UNITED STATES PATENT AND TRADEMARK OFFICE

APPLICATION NO.	FILING DATE	FIRST NAMED INVENTOR	ATTORNEY DOCKET NO.	CONFIRMATION NO.
09/986,614	11/09/2001	Masaki Shimada	02860.0695	5939

Office Action Summary

DETAILED ACTION

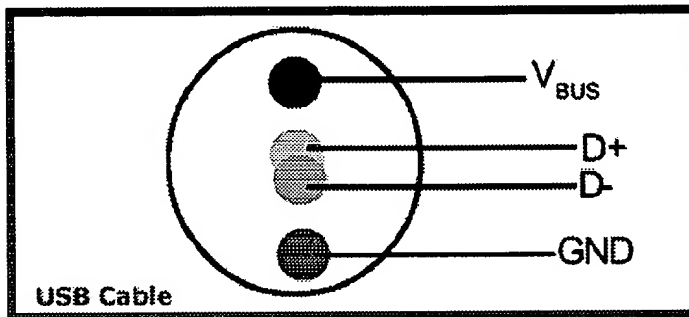
supplied between the device (50) and the external device (host device 10/ upstream host or camera 54), wherein the interface cable also includes the data communication path and the power-supplying path (the USB devices of Hannah must be in full compliance with the USB specification; wherein the USB cable transfers both power and data. A typical USB cable is shown below:

; wherein Vbus is 5V at the source and a twisted wire pair for data); a data-storing unit (the storage medium of VCR 50) to store the data sent from the interfacing circuit; and a plurality of interface connecting ports (privileged upstream port or host port and hub port 56) serving as input/output terminals of the interfacing circuit, wherein the interface cable can be connected to one of the interface connecting ports.

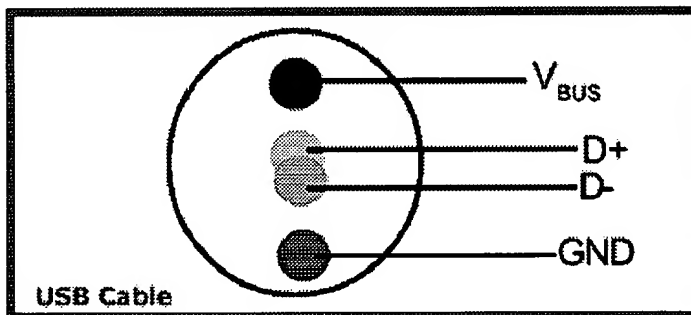
With regard to claim 1, 954 discloses a device for storing data (30), comprising: an interfacing circuit (USB interface) that includes a data communication path through which the data can be bilaterally communicated between the device (30) and an external device (20), which is coupled to the device (30) with an interface cable (it is inherent that a USB cable is need to provide USB connections between devices or nodes), and a power-supplying path through which a power current can be bilaterally supplied between the device (30) and the external device (20), wherein the interface cable also includes the data communication path and the power-supplying path (the USB devices of 954 must be in full compliance with the USB specification; wherein the USB cable transfers both power and data. A typical USB cable is shown below:

; wherein V_{bus} is 5V at the source and a twisted wire pair for data); a data-storing unit (FDD 21) to store the data sent from the interfacing circuit; and a plurality of interface connecting ports (ports for external device 20, keyboard 3 and mouse 4)
